# CLAREMONT BUSINESS PARK 2 FIL. NO. 1 - LOT 3

## EL PASO COUNTY, STATE OF COLORADO GRADING & EROSION CONTROL PLAN

EPC STORMWATER REVIEW COMMENTS ARE SHOWN IN ORANGE BOXES WITH BLACK TEXT

GRADING & EROSION CONTROL PLAN  
CLAREMONT BUSINESS PARK 2 FIL. NO. 1 - LOT 3  
JOB NO. 44-037  
DATE PREPARED: FEBRUARY 15, 2021  
DATE REVISED:

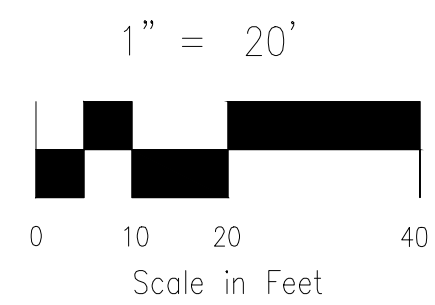
Adjust limits of disturbance to include disturbance on lot 3.  
adjust silt fence as well.

SHEET 2 OF 3

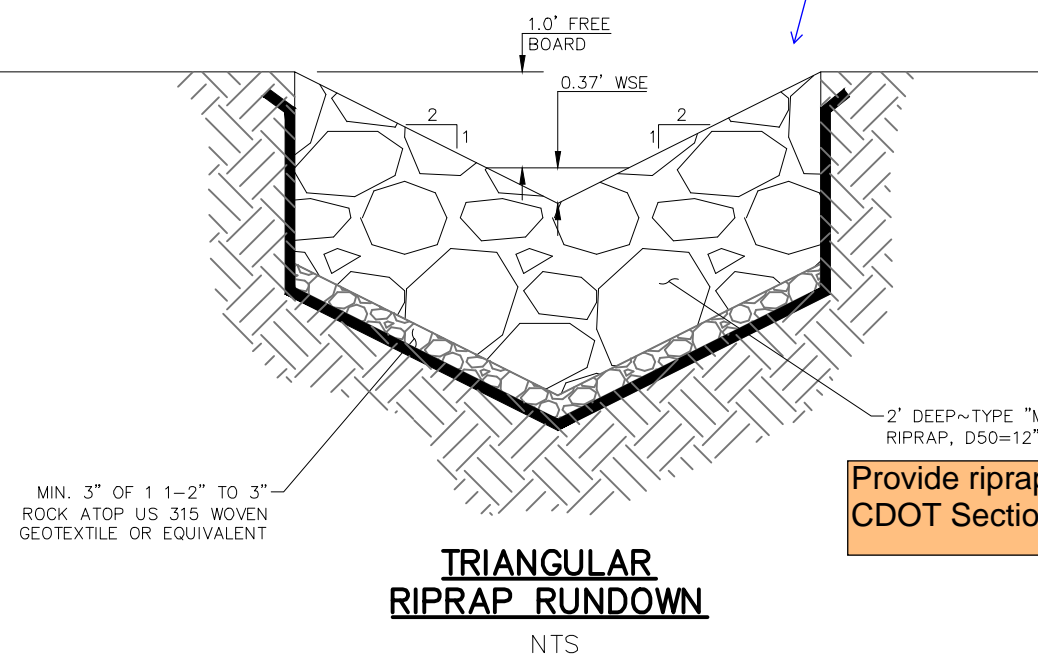
show areas of temporary and permanent seeding.  
add symbol to legend

Add a note about existing vegetation and percent cover (prior to early grading).

Add a note stating no asphalt/concrete batch plants are associated with this project.

Add a note stating there are no springs, streams, or wetlands at the Site.

Label all proposed temporary construction control measures by phase of implementation (initial, interim, final)

Update to show sidewalk around driveway per SF-2014 approved construction plans.

Adjust limits of disturbance to include rundown.

Revise to reference sheet 2, since detail is below.

label lot number

If "limits of disturbance" and "construction boundary" are the same, change to "construction boundary/limits of disturbance" or otherwise show as separate line types for each on the legend and figure.

show areas of cut/fill

Provide riprap gradation table and note that CDOT Section 506 Requirements apply
